# 2006 - 2009 Cadillac XLR: Service Bulletin: #PI0299: Harsh Shifts After Replacement of 1-2-3-4 / 3-5-R Clutch Housing

## #PI0299: Harsh Shifts After Replacement of 1-2-3-4 / 3-5-R Clutch Housing - (Nov 16, 2010)

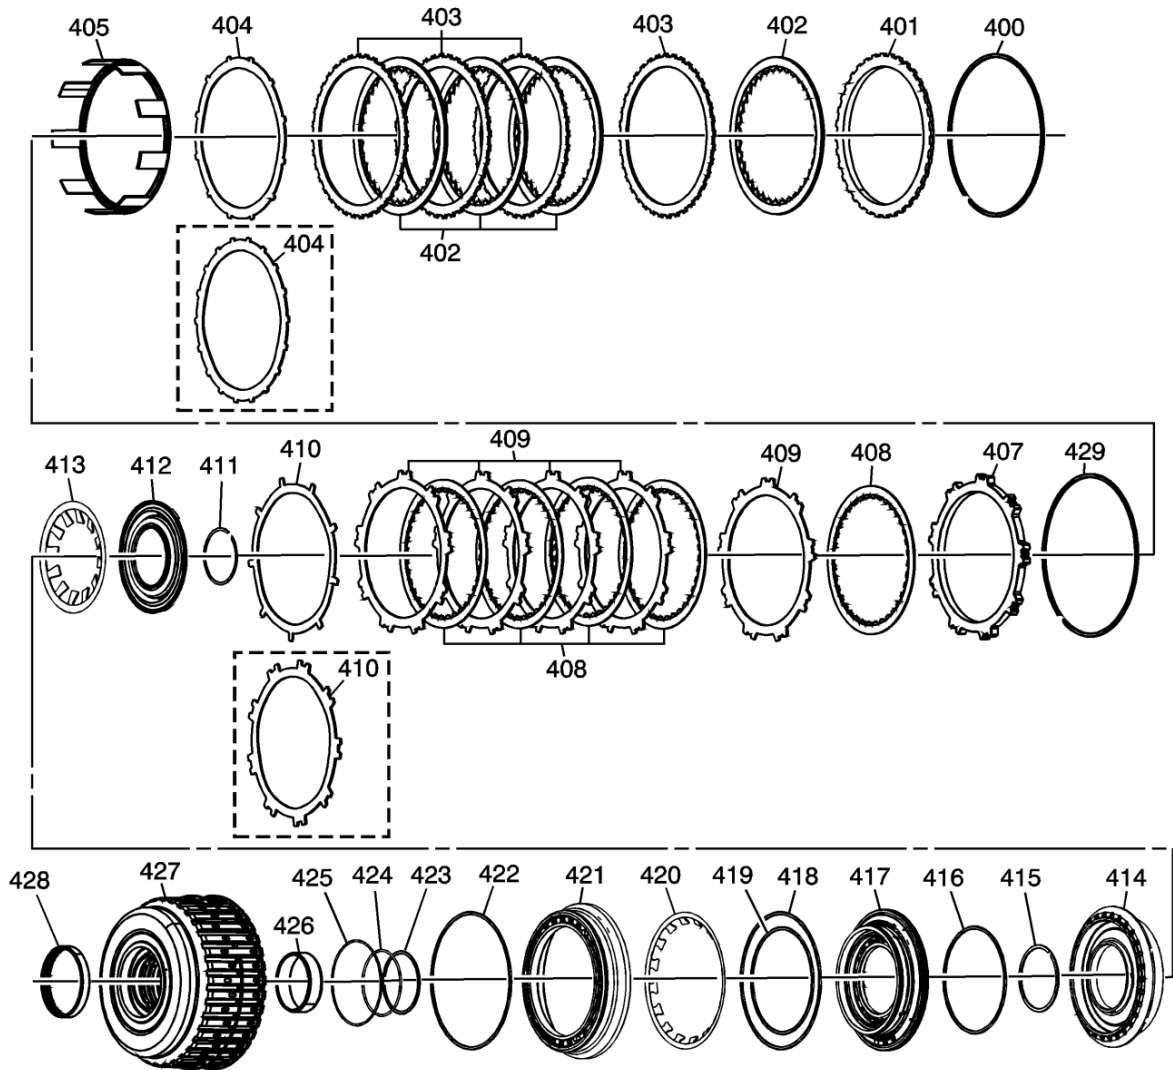
Some customers may comment on harsh shifts after replacement of the 1-2-3-4 / 3-5-R clutch housing (427).

This condition may be caused if the 1-2-3-4 / 3-5-R bearing (428) is not installed into the housing (427). The 1-2-3-4 / 3-5-R clutch housing is currently serviced through parts without this bearing installed and failure to order and install this bearing may result in harsh shifts. Plans are being implemented to service this housing as a kit that will include

**Note:** The parts catalog calls out to order the bearing when the housing is also replaced.
